November 1, 2022

ADDENDUM 2

Walnut Valley Unified School District
Diamond Bar High School
Building 400 Modernization New Classrooms/Library Media
DSA #03-121330 | File #19-H52

M2.12

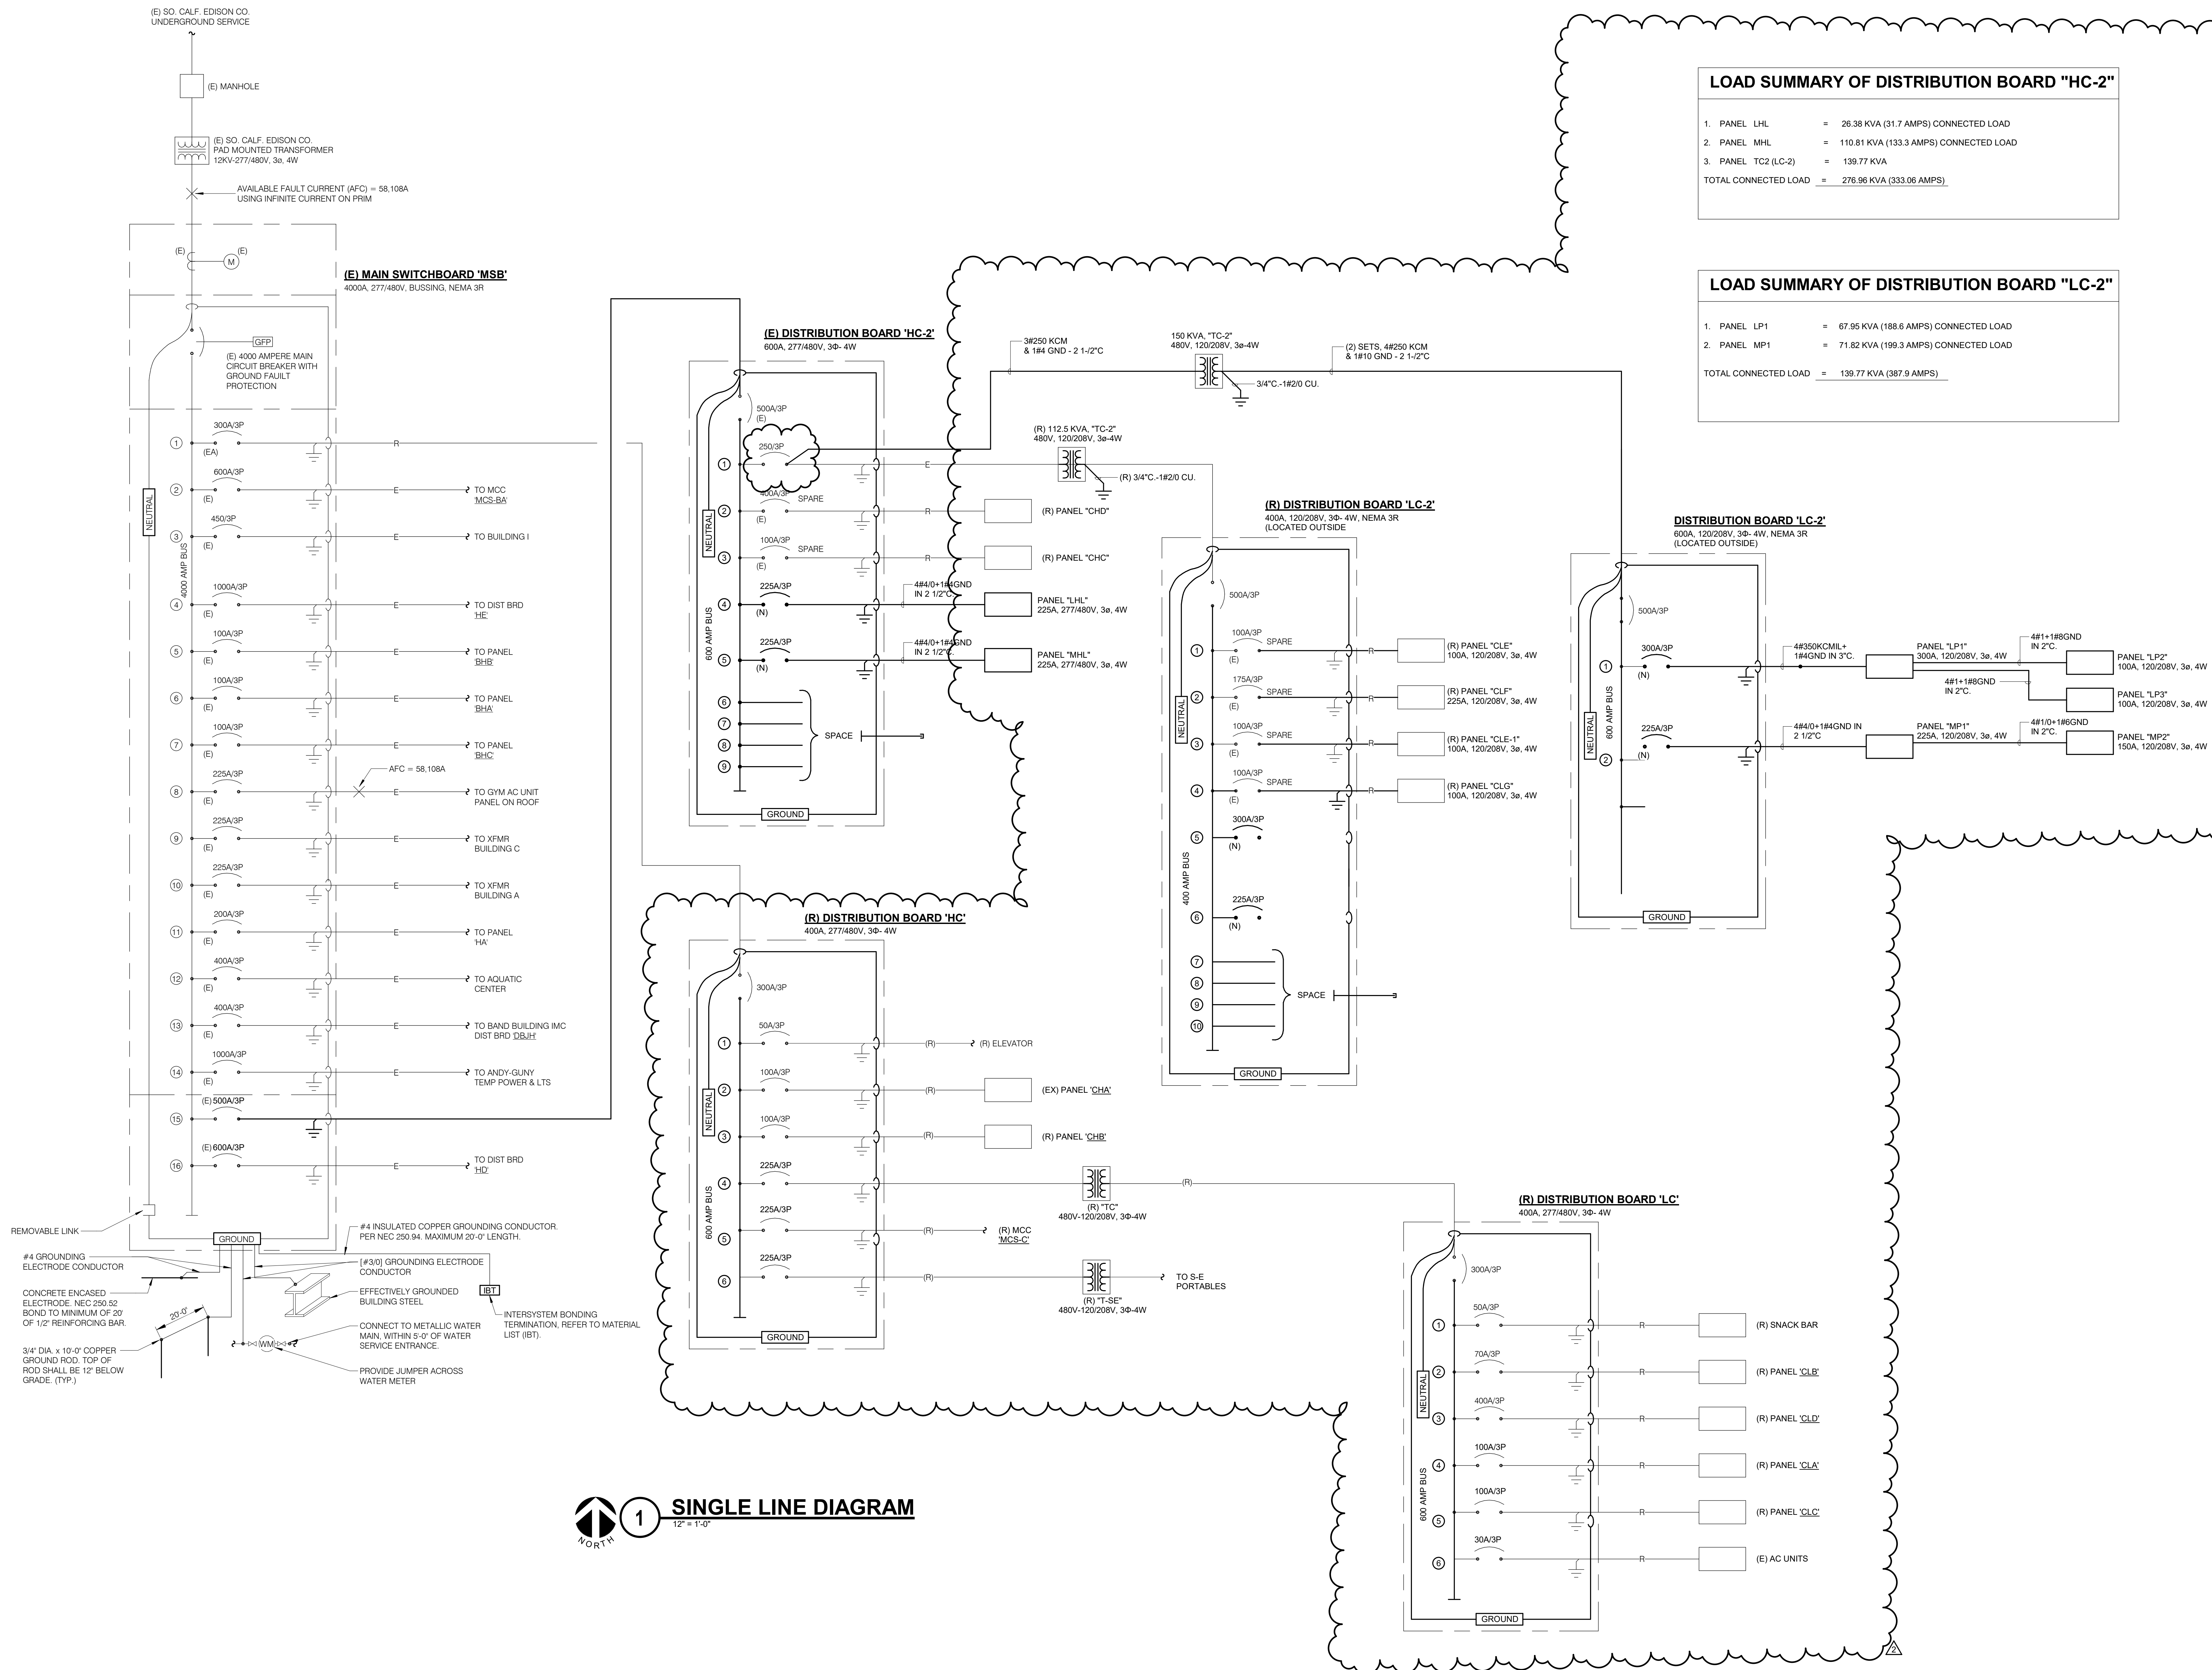
M2.12 REMODEL FLOOR PLAN MAIN LEVEL

- A. RELOCATED THE 16 X 14 DUCTWORK ASSOCIATED TO AC-8 TO PASS THROUGH GRIDLINE 7 ABOVE THE DOUBLE DOORS.
- B. ADDED KEYNOTE 6.
